Executive Director's Recommendation
Commission Meeting: July 11, 2013

Phase 2 (South Campus), Centrum
Intelligence Community Campus - Bethesda
(MP7257)
4600 Sangamore Road
Bethesda, MD

Final approval of site and building
plans

Figure 13: Roof plan of Centrum
(Image date: June 6, 2013)

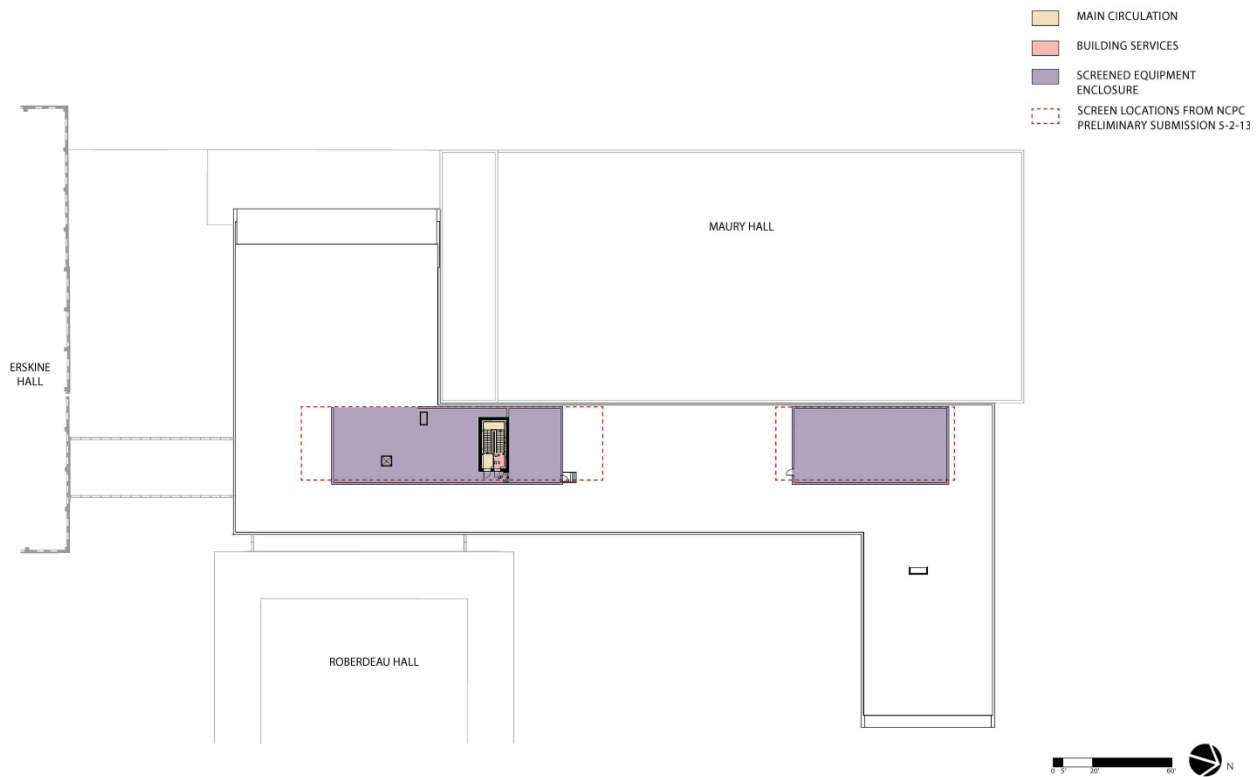
In regards to the mechanical penthouses proposed for the Centrum, within its preliminary review, the Commission requested that the applicant evaluate whether any reductions in the penthouse height and massing can be made, and to evaluate setting back the penthouses from all exterior walls a distance greater than or equal to their height in order to further minimize any potential views of the penthouses from the west, and strengthen the architectural presence of the Centrum when viewed from the east. In response, the applicant was able to eliminate the northeastern-most penthouse, which provided roof access, by replacing it with a roof hatch. In addition, the applicant reduced the footprints of the remaining two penthouses by reducing their north / south lengths. This, in turn, has reduced their respectable distances from both the north and south walls of the Centrum. (Figure 13) However, the applicant notes in their final submission materials that the use of smaller HVAC units was explored but that they found no other equipment that met program requirements at a smaller scale. As such, the proposed height of the penthouse enclosures has remained at 12 feet, as presented in the preliminary review, to minimize the visibility of the HVAC units. (Figure 14)

Figure 15: Location of Centrum's green roof
(Image date: June 6, 2013)

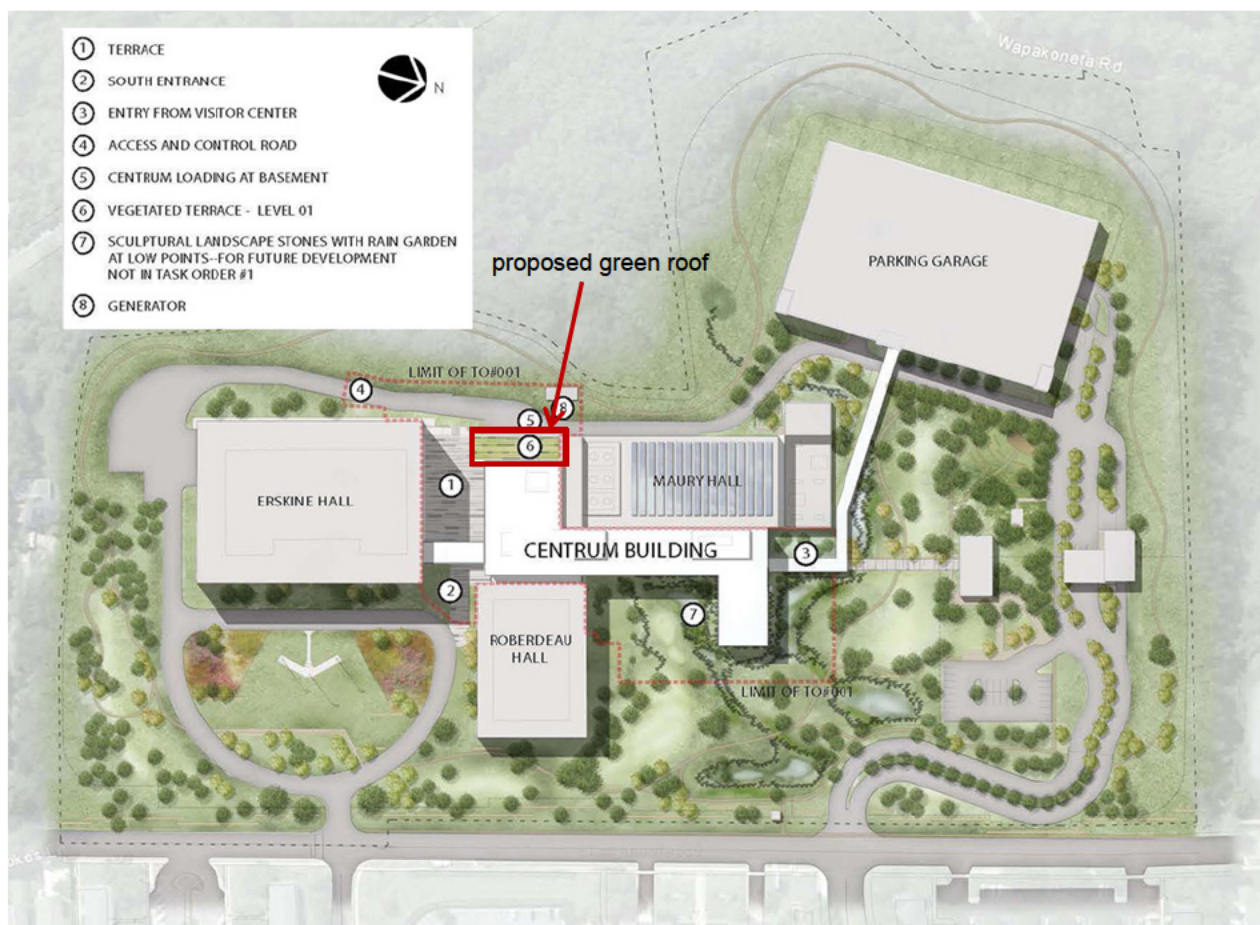
The proposed green roof is only located over the loading dock, an area of approximately 3,600 square feet. (Figure 15) This is a relatively small portion of the total Centrum roof area which measures approximately 41,000 square feet. The Commission, at its preliminary review of the project, requested that the applicant consider expanding the area of the proposed green roof and to design the system to the greatest depth possible. In response, the applicant states that an

expanded green roof system would require substantial structural upgrades to the Centrum building and that to design the proposed system to the greatest depth possible would require a vertical expansion of the height of the green roof structure because it would need to occur above the structural roof slab of the floor below. The applicant also notes that from a stormwater perspective, it is more cost effective to treat stormwater at grade level than on occupied structure, but will continue exploring additional stormwater management opportunities that are both

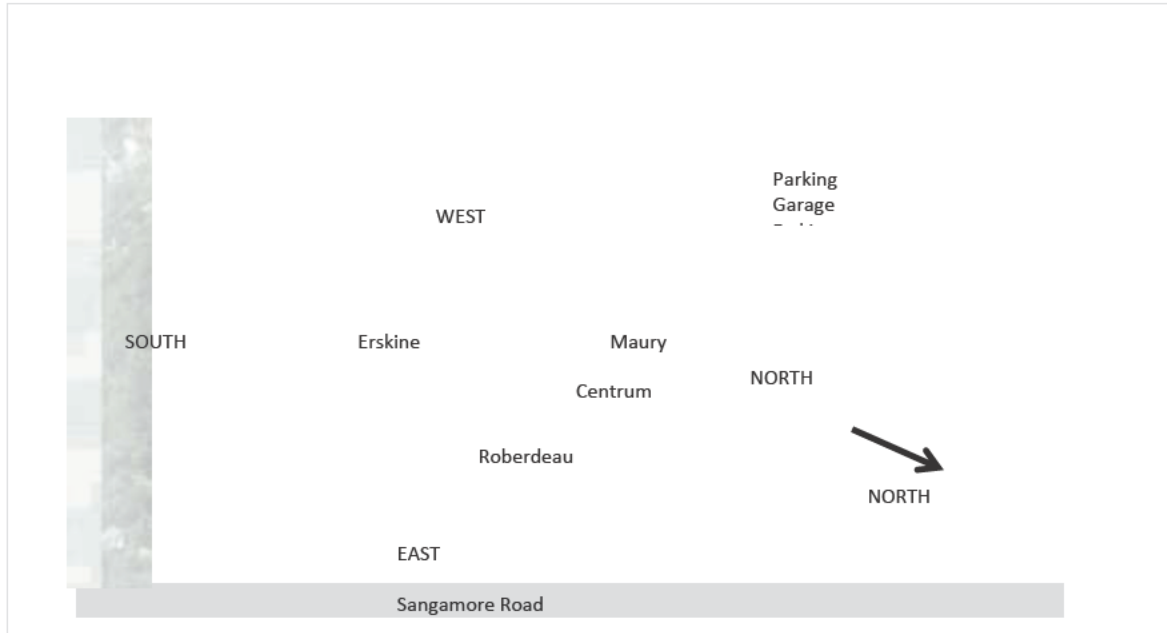
The aluminum panels raise similar issue to that of the glass walls in terms of visibility. Color changes in appearance depending on the time of day and weather conditions. The design team has said that they will be testing the colors on the site and getting input from the community. Looking for built examples using similar materials and color variations for viewing at different times and under different conditions would be useful and is one way to see how color on a test panel might look when applied to a building.
